Project	IEEE 802.16 Broadband Wireless Access Working Group < http://ieee802.org/16 >	
Title	Prescribing the timing for MAC PDU transmission	
Date Submitted	2007-07-05	
Source(s)	Rakesh Taori, Ki-Sun Oh, Mi-Sun Do Samsung Advanced Institute of Technology	Voice: +82 31 280 9635 E-mail: rakesh.taori@samsung.com
	Hyunjeong Kang and Jungje Son Samsung Electronics	*< http://standards.ieee.org/faqs/affiliationFAQ.html >
	Mary Chion, Jerry Chow, Hongyun Qu ZTE	mchion@zteusa.com
Re:	In response to the call for comments and contributions on the IEEE 802.16j baseline draft (802.16j-06/26r4).	
Abstract	[Description of document contents.]	
Purpose	Discussion and Adoption in the IEEE 802.16j baseline draft	
Notice	<i>This document does not represent the agreed views of the IEEE 802.16 Working Group or any of its subgroups. It represents only the views of the participants listed in the "Source(s)" field above. It is offered as a basis for discussion. It is not binding on the contributor(s), who reserve(s) the right to add, amend or withdraw material contained herein.</i>

Prescribing the timing for MAC PDU transmission

Rakesh Taori, Ki-Sun Oh and Mi-Sun Do
Samsung Advanced Institute of Technolo

Figure 22a: Header format of relay MAC PDU with payload

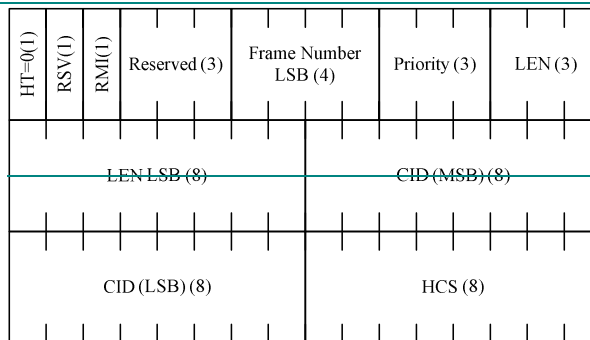
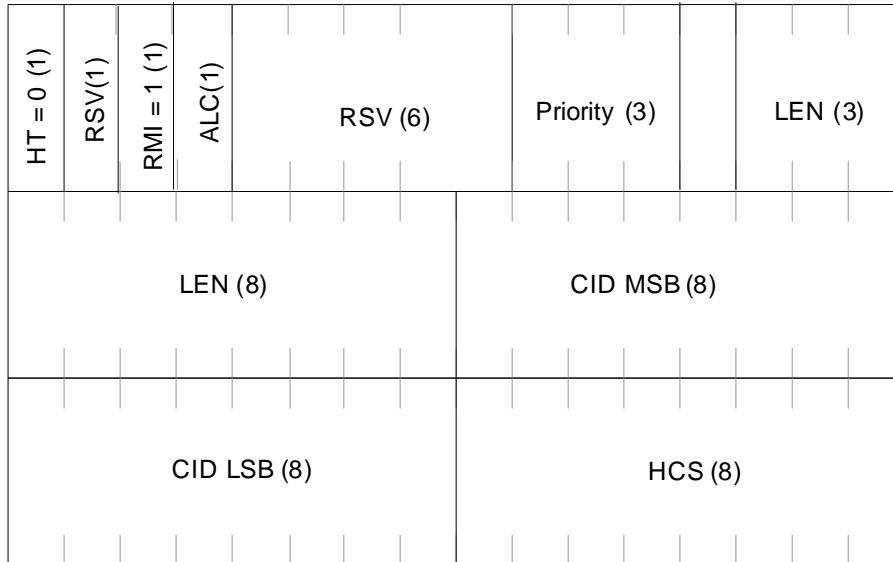
Modify Figure 22a as shown below:
